## STARKER AVENUE RESURFACING ASSESSMENT DISTRICT - 2024

CITY PROJECT NO. 14780  
CONTRACT NO. 8759

**Addendum 1 - RJN - 11/8/24**  
 - Changed "install temp hydrant to "install temp flushing device"

MARK	REVISION	DATE	BY
14780	11/8/2024 12:38 PM	1" = 40'	W-3

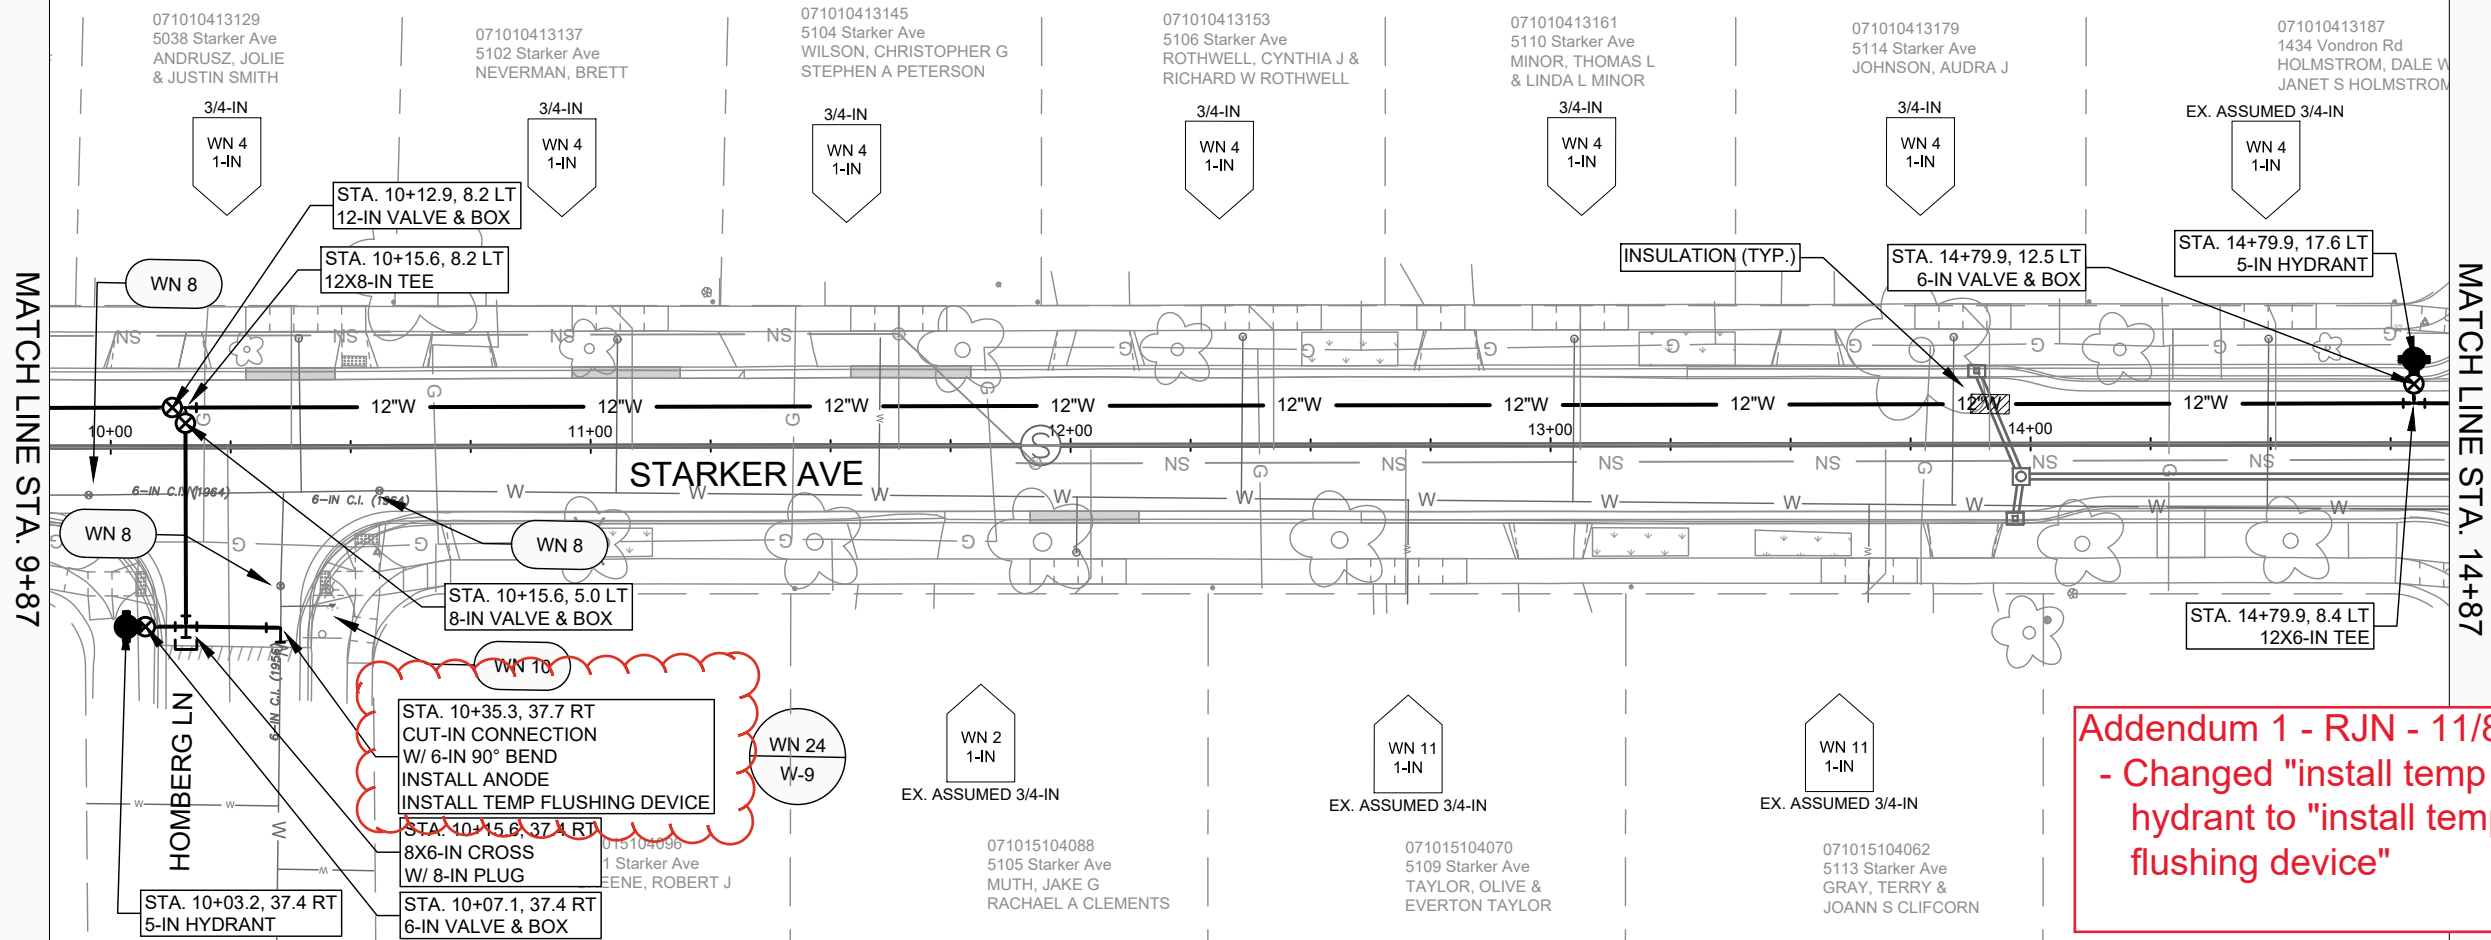
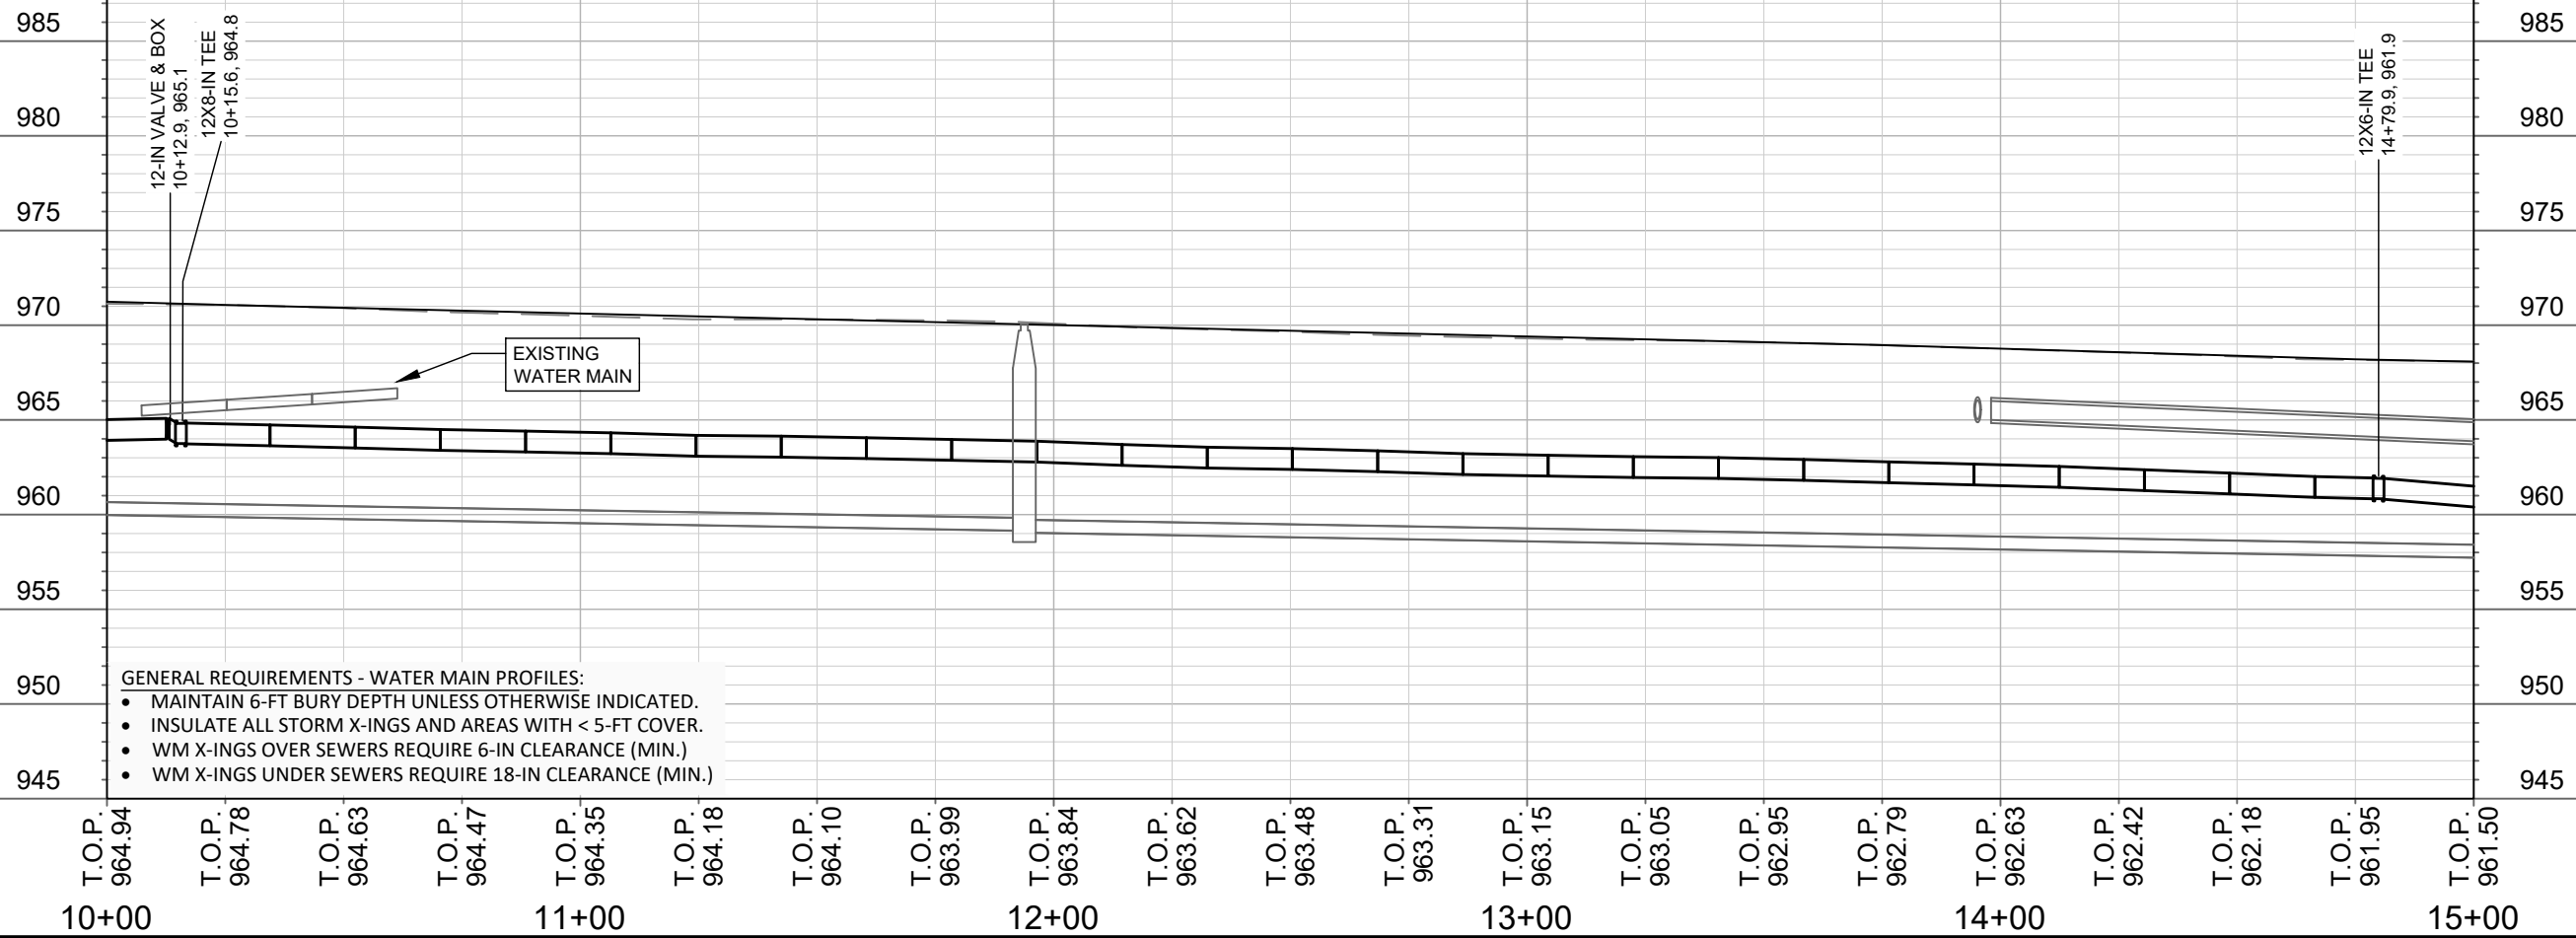
Addendum 1 - RJN - 11/8/24  
 - Changed "install temp hydrant to "install temp flushing device"

MARK	REVISION	DATE	BY
14780		11/18/2024 12:38 PM	W-4

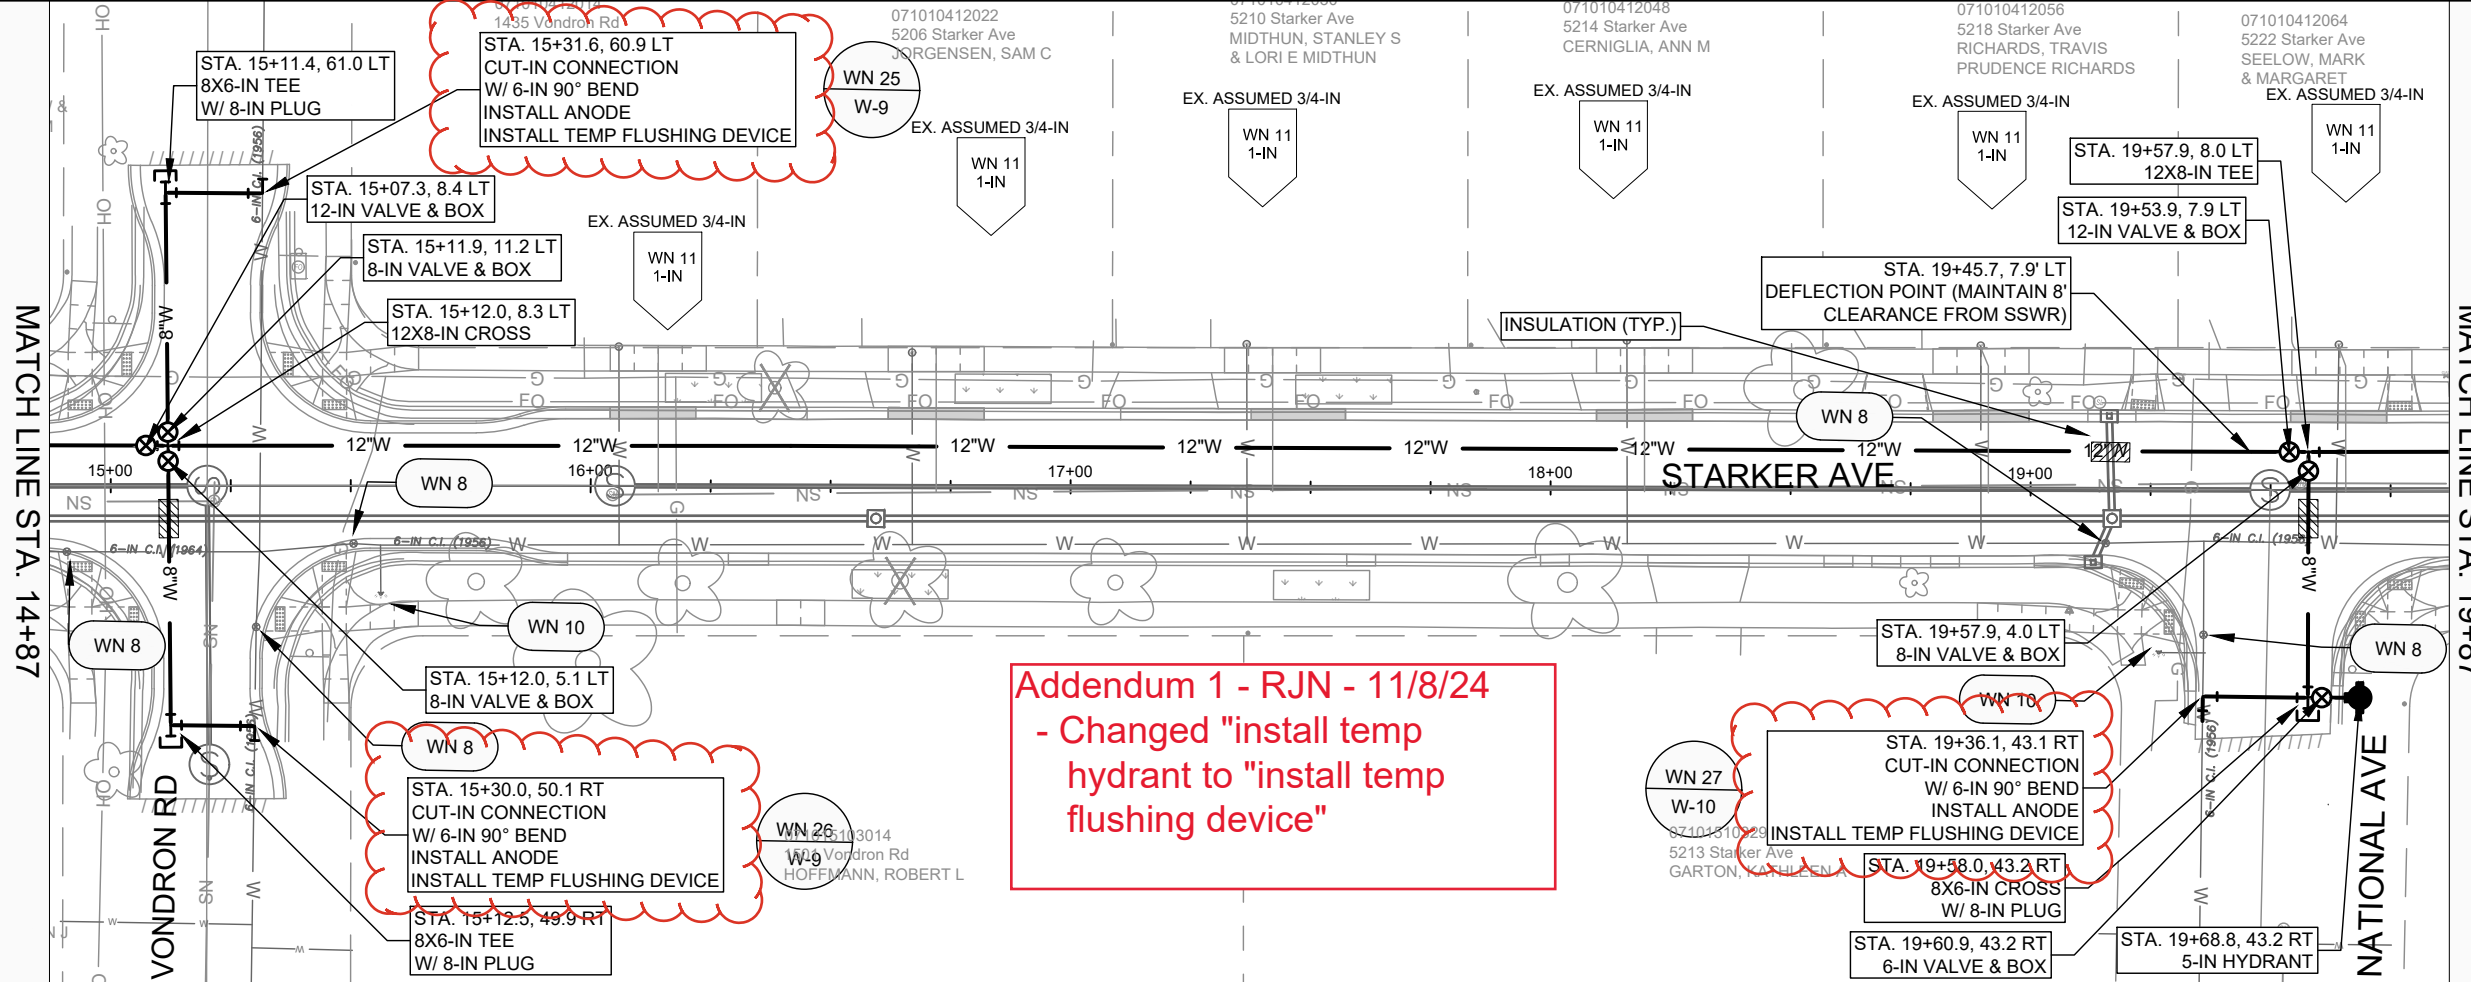
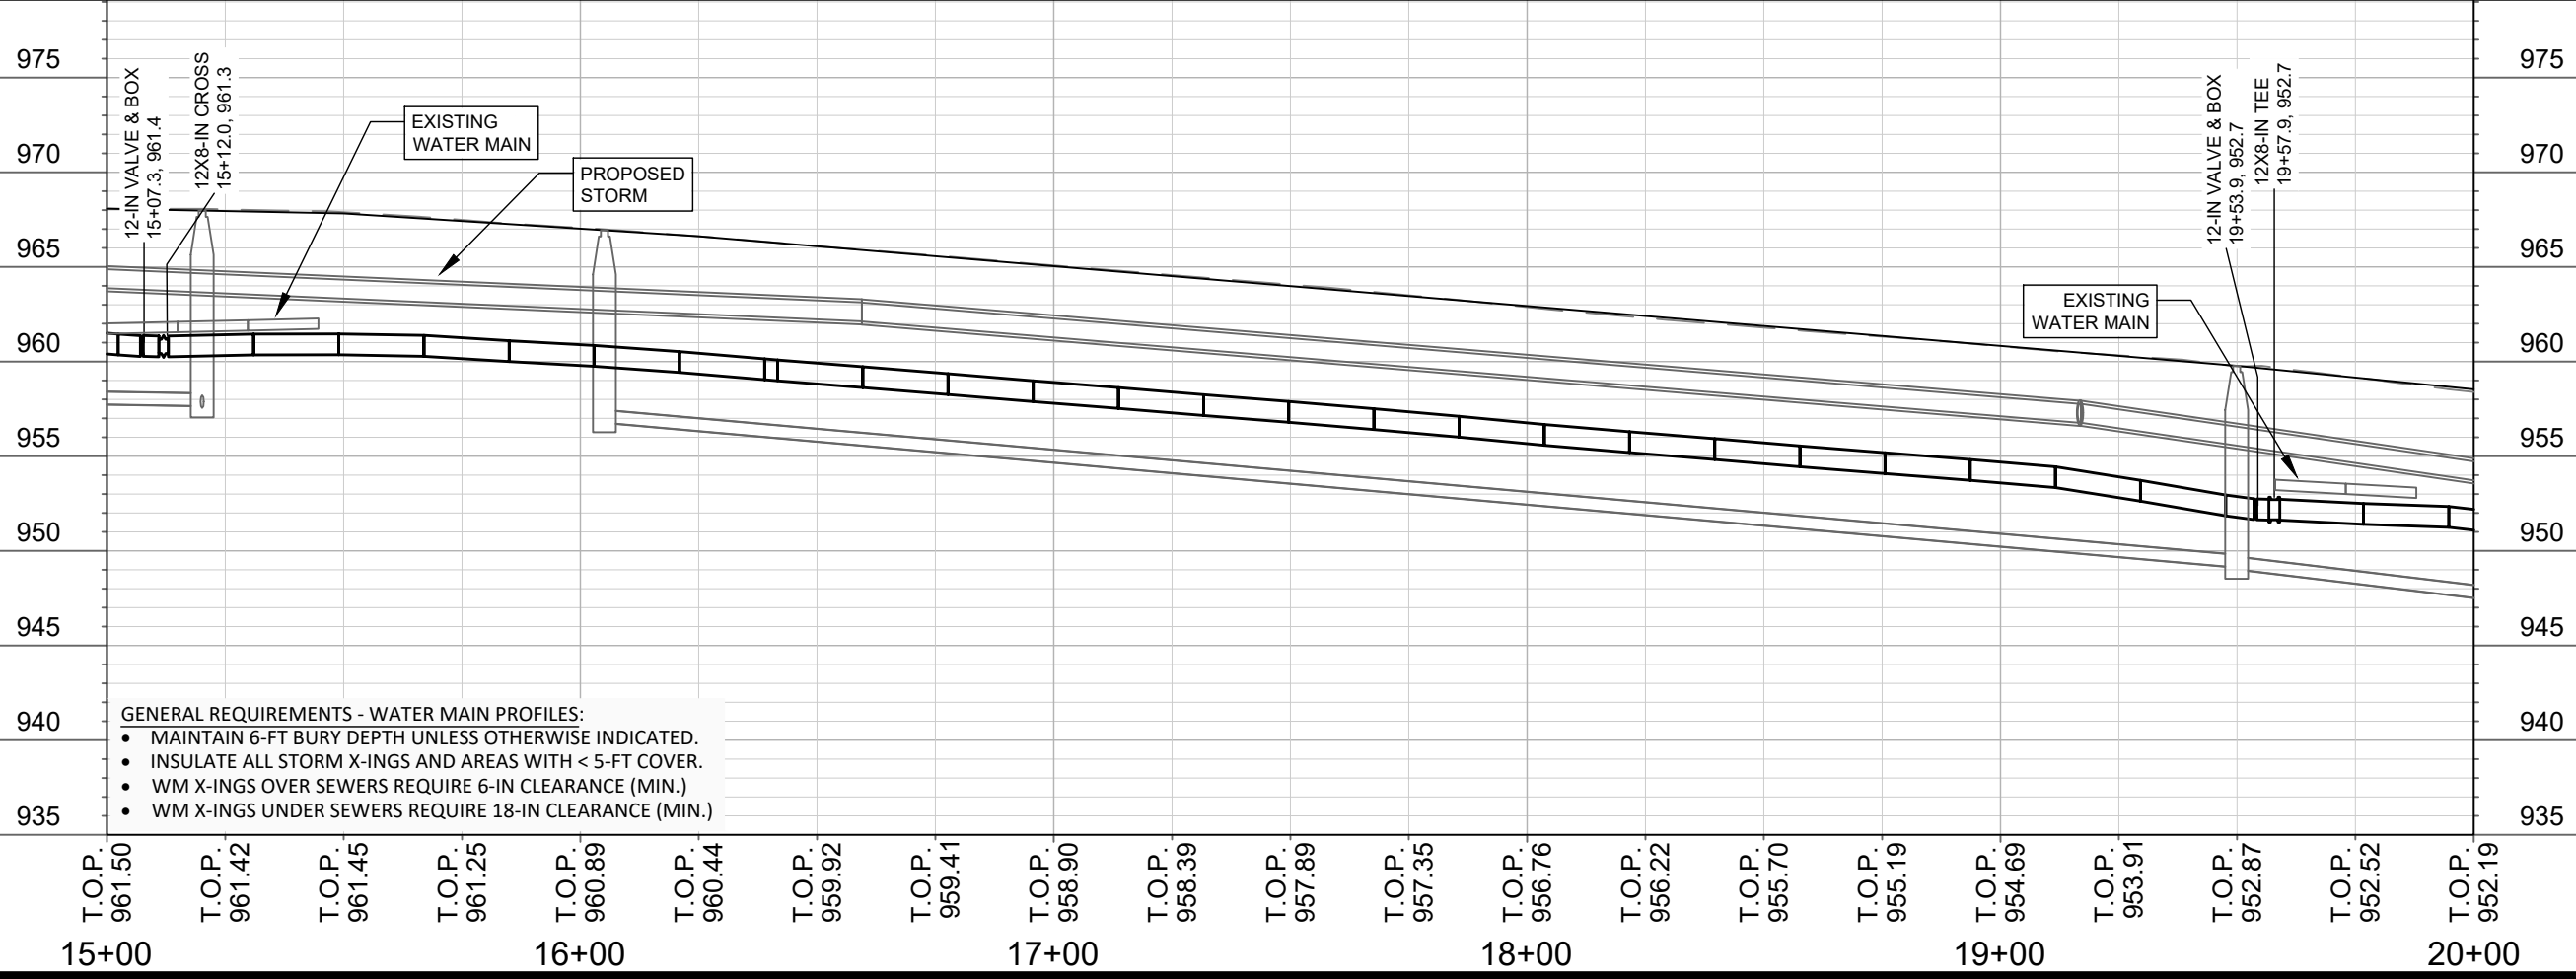
**Addendum 1 - RJN - 11/8/24**  
 - Changed "install temp hydrant to "install temp flushing device"
